Re: Second Addendum Soil and Ground-Water Investigation Work Plan
Atlantic Richfield Company Station #771
899 Rincon Avenue
Livermore, California
ACEH Case RO0000200

Project No. 06-82-608

Re: Second Addendum Soil and Ground-Water Investigation Work Plan, Atlantic Richfield Company (a BP affiliated company) Station #771, 899 Rincon Avenue, Livermore, California. Case No. RO0000200.

enclosure: Drawing 1: Site Location Map
 Drawing 2: Site Map with Proposed Boring Locations

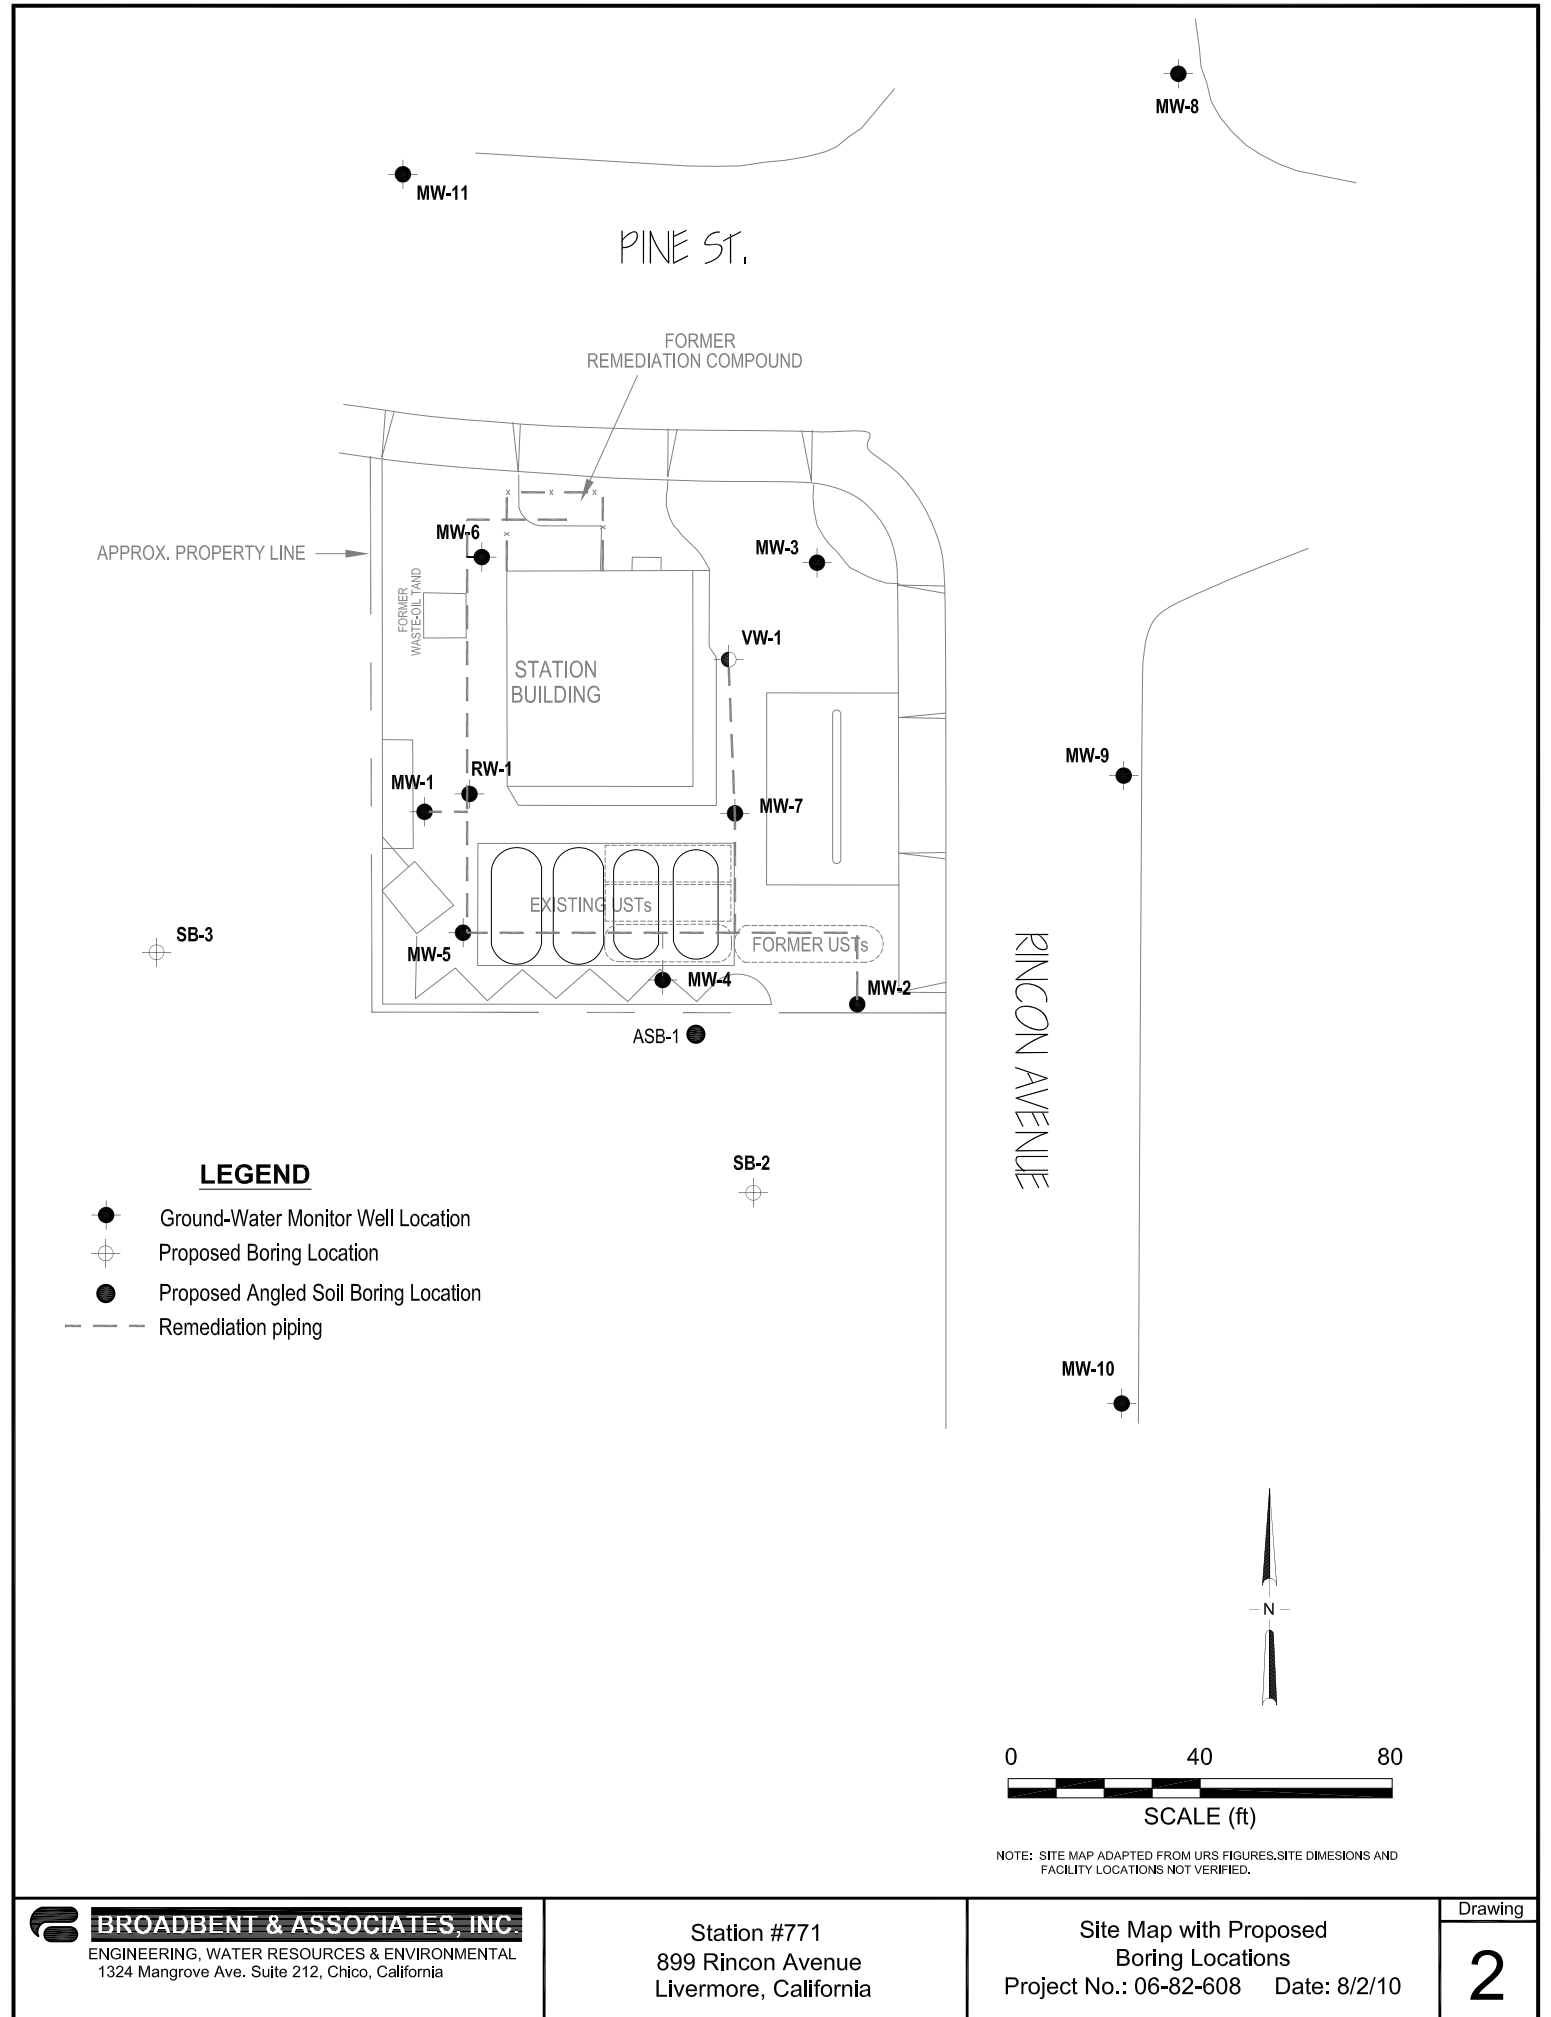
Upon further discussions with the lawyers representing the Livermore Shopping Center and ACEH, installation of the two proposed offsite monitoring wells is not the preferred scope of work for the owner of the Shopping Center. Therefore, it is proposed to install two off-site soil borings to collect one-time soil and ground-water samples. The two proposed borings, SB-2 and SB-3, will be located in the same locations as previously recommended wells MW-12 and MW-13. A Site Location Map is provided as Drawing 1. A Site Map with Proposed Boring Locations is provided as Drawing 2. Additional soil and ground-water sampling details for SB-2 and SB-3 (including laboratory analysis) will follow what was already proposed in the original Work Plan for off-site wells MW-12 and MW-13 (BAI, 2/10/2009). Due to dense soil conditions previously observed at the Site during drilling activities, it is proposed to use a hollow-stem auger drilling method for each of the soil borings. Each boring will be continuously sampled during drilling activities in order to obtain an accurate description of the lithology at each location.

discussed above, proposed soil borings SB-2 and SB-3 and angled soil boring ASB-1 are all located on the neighboring Shopping Center property. With a signed access agreement in place, BAI will execute the proposed field work. If a signed access agreement is not in place following 90 days from approval of this Second Addendum Work Plan by ACEH, further assistance with access agreement negotiations from ACEH may be requested. Upon completion of field work and receipt of the laboratory analytical report, BAI will complete a soil and ground-water investigation report for submittal to ACEH.
